T-13524

**BEFORE THE WATER RESOURCES DEPARTMENT
OF THE
STATE OF OREGON**

In the Matter of Special Order Volume)
120, Pages 83-88 approving T-13524, Lake)
County)

CORRECTING ORDER

Groundwater Transfer Application T-13524 (Temporary) JR Simplot Properties III, LLP (To Wells)

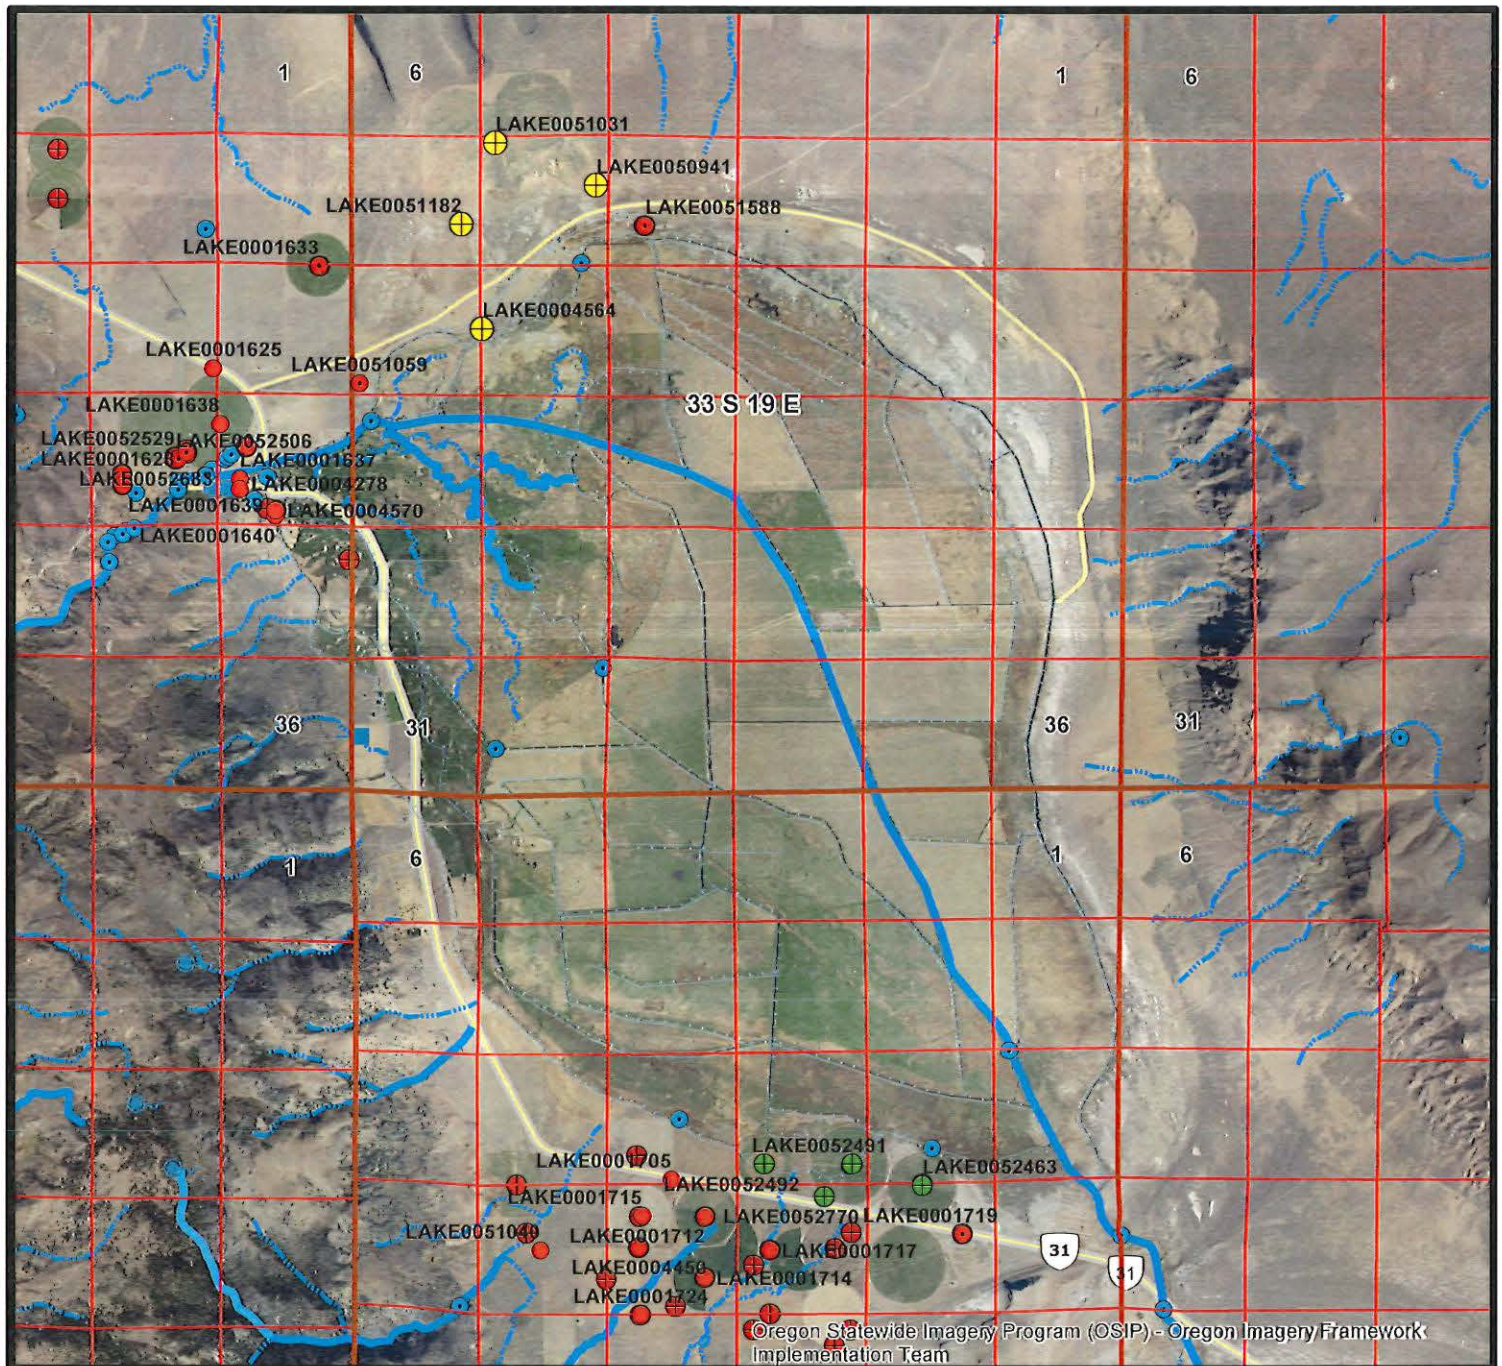
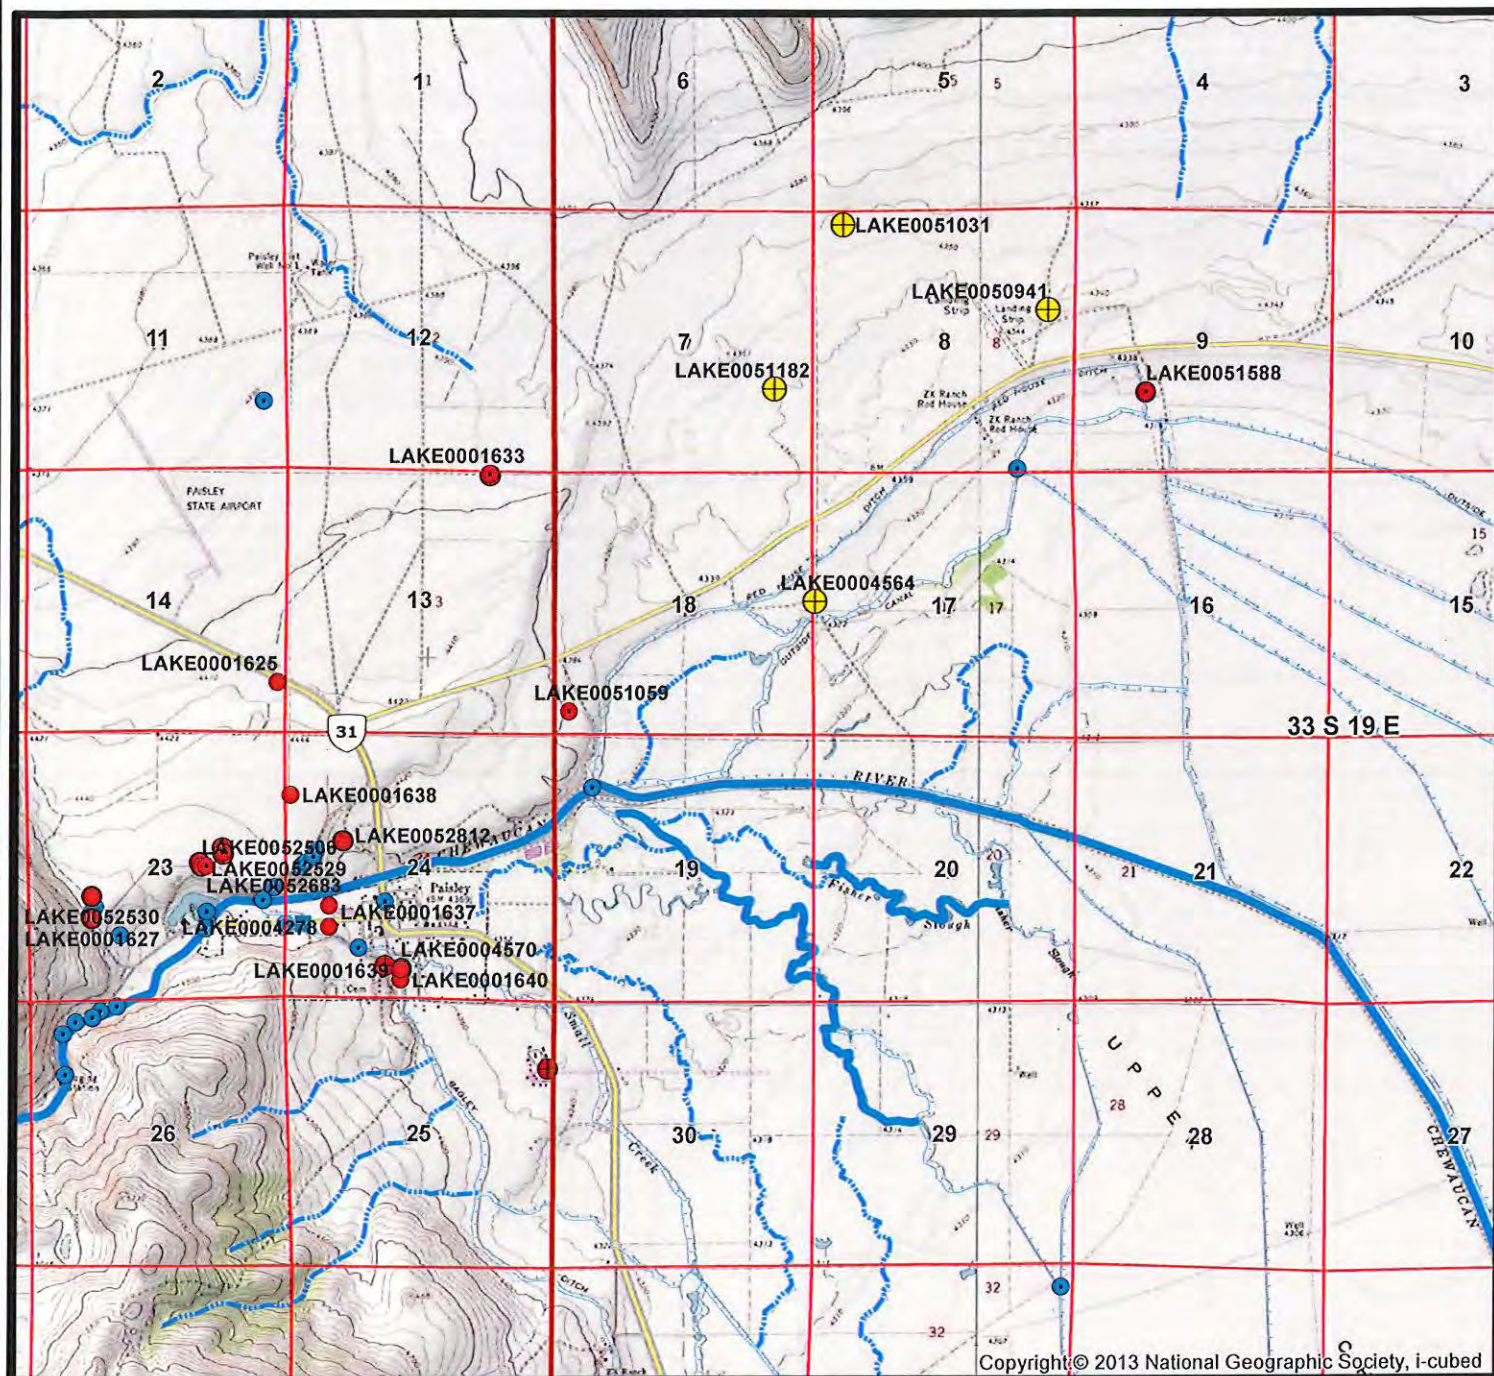
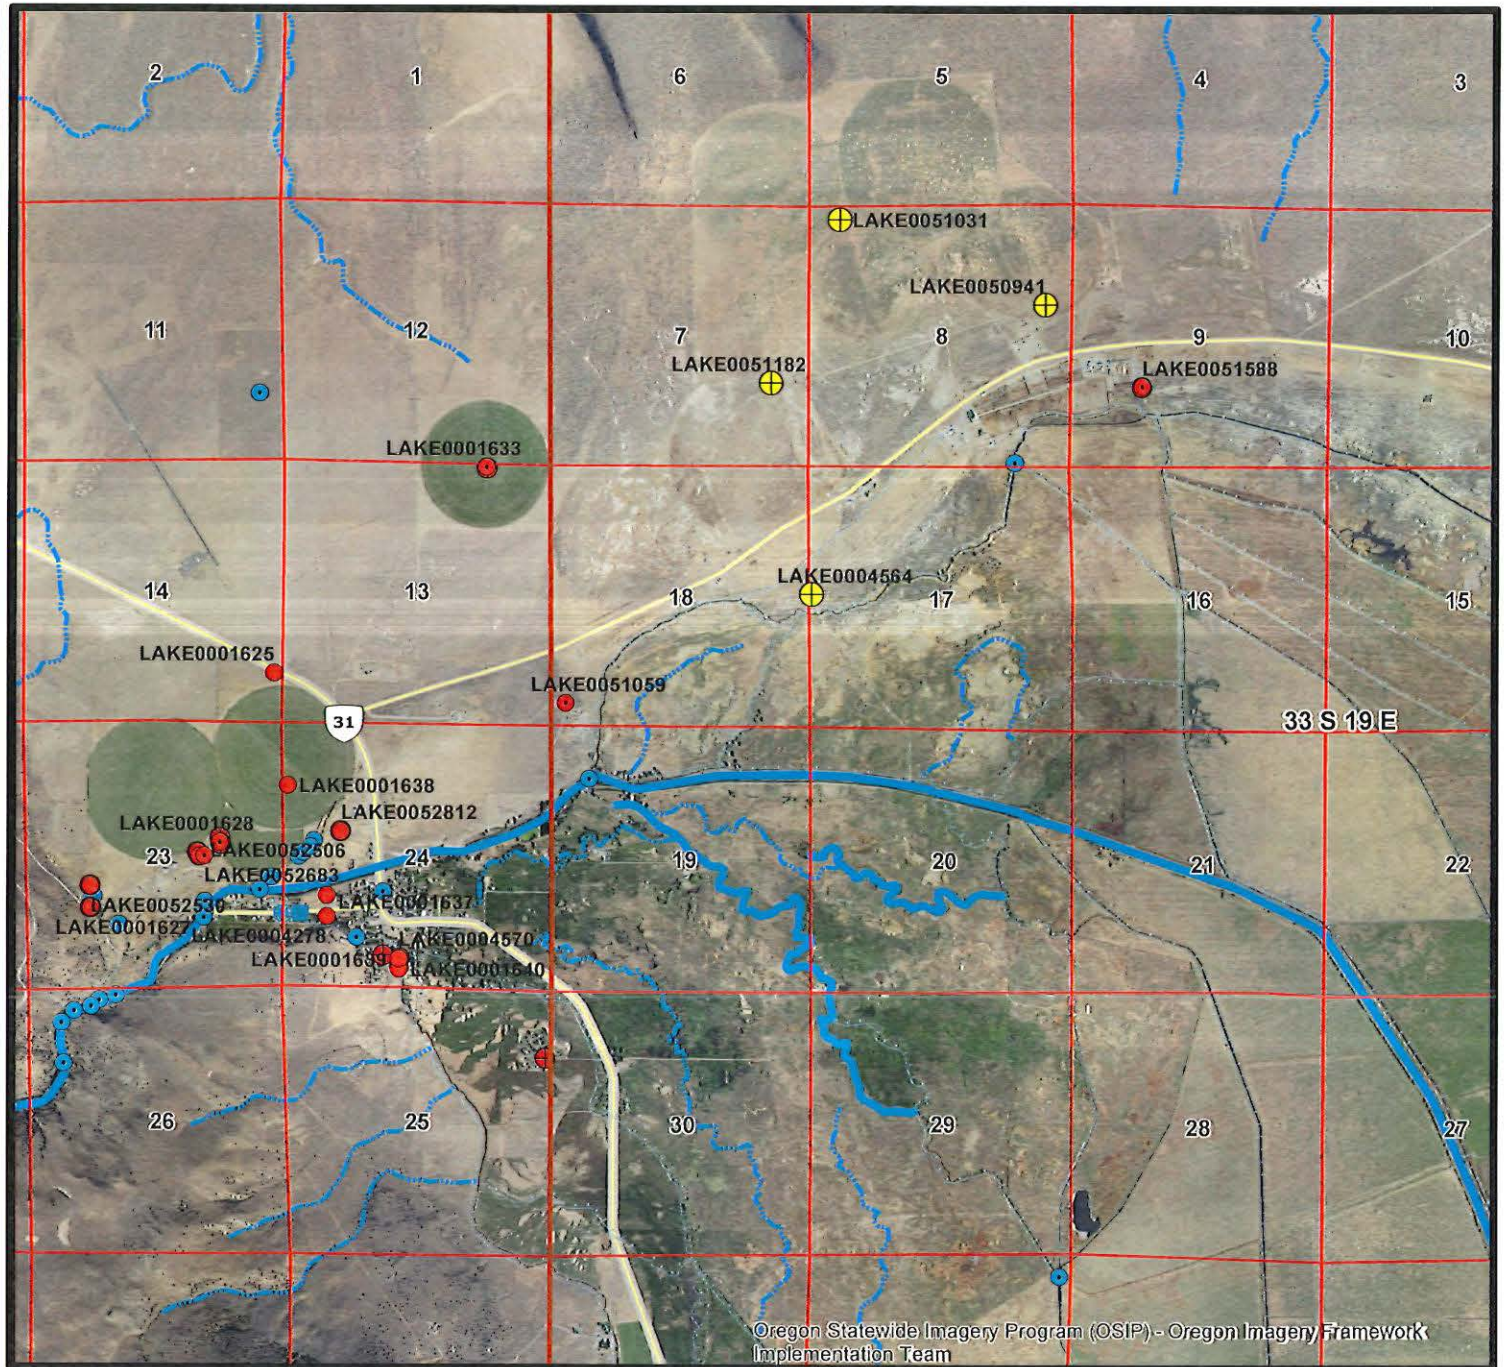
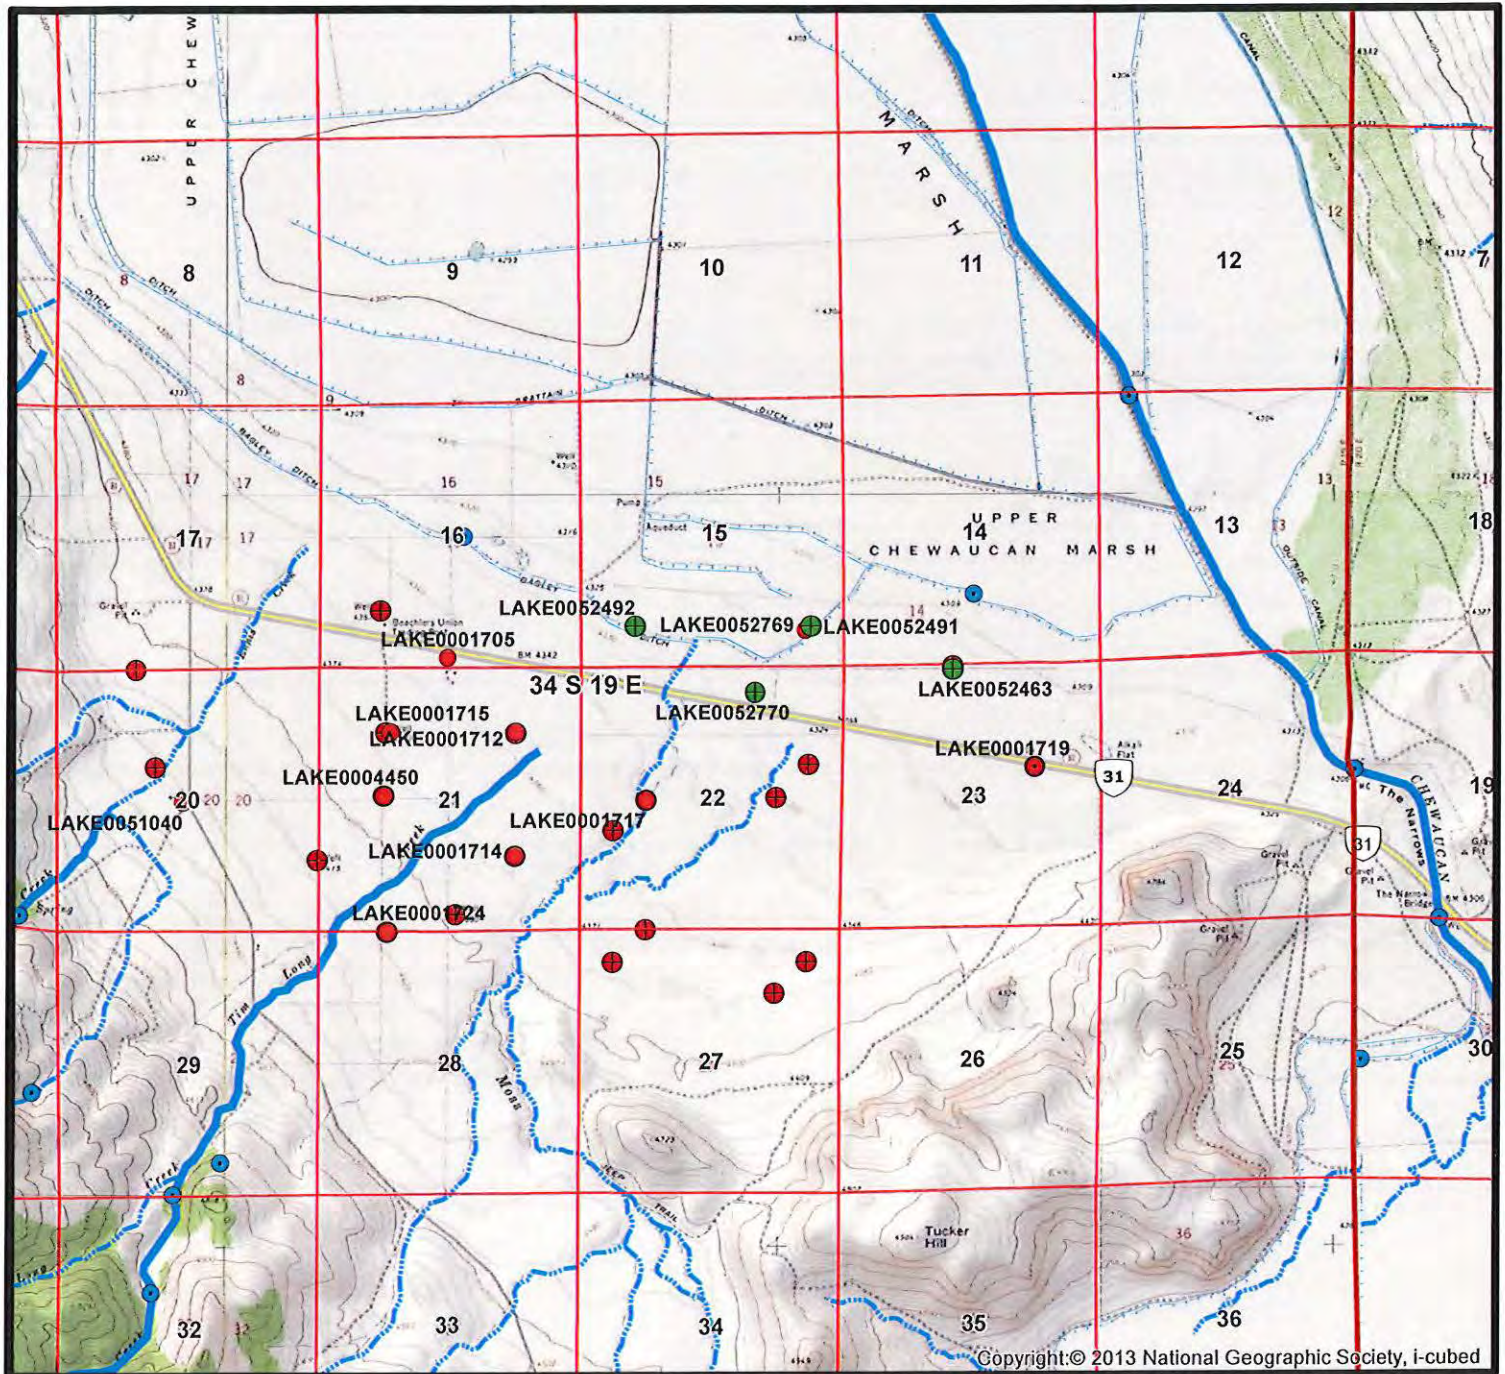
This proposed POA change is less protective of shallower wells and surface water. To be similar to the "From" wells, the "To" wells should ideally obtain 75% or more groundwater from the deeper predominantly volcanic rock and sediment unit.

Yes. The proposed change will move groundwater pumping about 6.8 to 8.8 mile south from the north side of Upper Chewaucan Marsh to the south side of Upper Chewaucan Marsh (see attached maps). The proposed change will move groundwater pumping closer to a different set of groundwater right wells (see attached maps).

Additionally, the proposed change moves groundwater pumping into a vicinity that may be experiencing a groundwater level decline since 2005 (see attached hydrographs for well LAKE 1719 [417-feet total depth]: data from all seasons and data from winter-spring only). The hydrograph for well LAKE 1719 showing data from winter-spring only shows relatively stable groundwater levels near 4302 feet elevation amsl from 1960 to the mid-1970s, a decline of about 5.5 feet from the mid-1970s to early 1980s to a new equilibrium of about 4297 feet elevation amsl that is close to the Chewaucan River stage near the Narrows (relatively steady from about 1980 to 2005), and an ongoing decline since 2005 of about 0.58 feet per year, possibly taking the groundwater level below the river bottom. The groundwater level decline in the 1970s and after 2010 appears to correspond to increased groundwater development in the area.

Condition 7P (well tag condition) for all the "To" and "From" POA wells.

Condition 7T (modified) for both the proposed "To" wells: "Prior to use, the proposed "To" wells shall be configured to allow a strictly clean water (no oil) static water level measurements with an electric-tape. That can include measurement access via an unobstructed vertical discharge pipe that allows the groundwater level to fluctuate freely within the discharge pipe (no valves, etc.). Otherwise, a dedicated measuring tube must be installed prior to use. The tube must be unobstructed, have a diameter of ¾ inch (0.75 inch) or greater, and pursuant to figure 200-5 in OAR 690-200."

Require continuous 1-hour groundwater level measurements via maintained recorder equipment and annual March hand measurements at wells LAKE 52769 and LAKE 52770. Recorder and hand measurement are to be submitted annually to OWRD within 30 days of the March hand measurement.
